ADDENDUM
TO THE
FINAL ENVIRONMENTAL IMPACT REPORT
FOR THE

49ers SANTA CLARA
STADIUM PROJECT

City of Santa Clara

August 2010

FIGURE 1

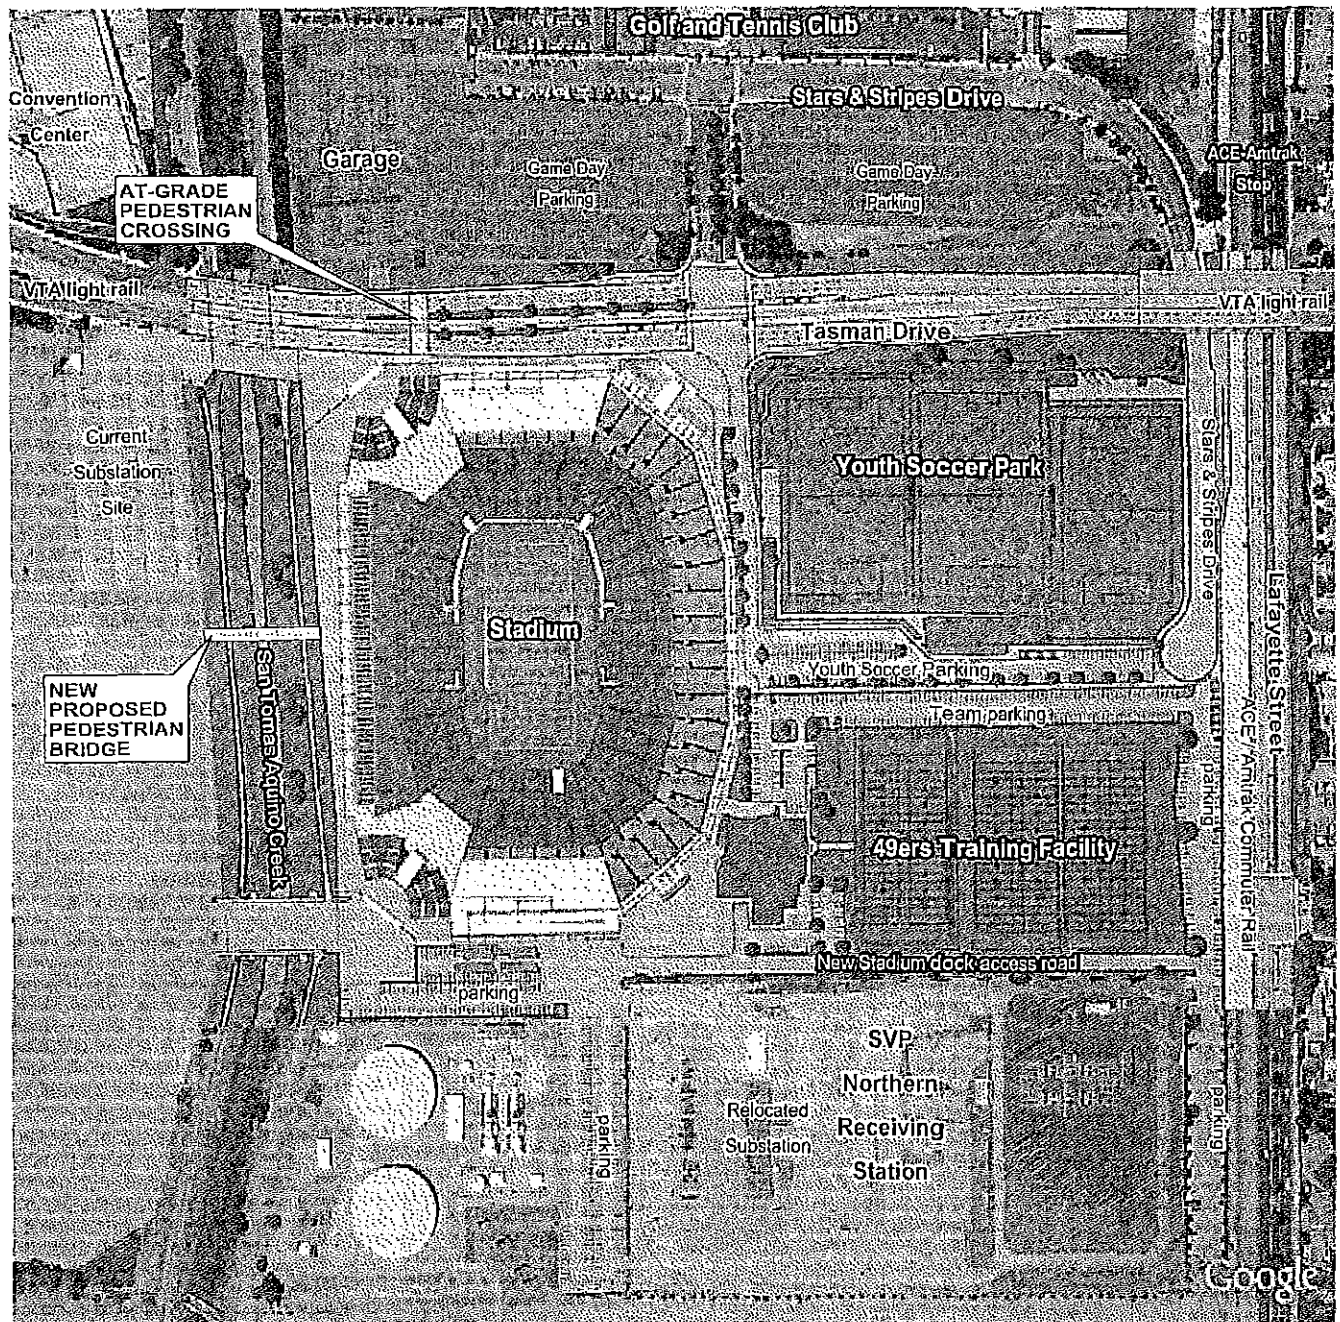
1. The addition of a third pedestrian bridge between the two pedestrian bridges proposed as part of the original project
2. Modification of the originally proposed mitigation to include a thermal water storage tank to supplement the proposed geothermal heat pump system.

3. The installation of a pedestrian walkway across the Valley Transportation Authority (VTA) Light Rail Transit (LRT) tracks for use during large stadium events and an associated safety gate and fencing around the affected tracks and Great America LRT station.

Figure 1 below shows the proposed location of the third pedestrian bridge and the pedestrian walkway across the VTA LRT tracks.
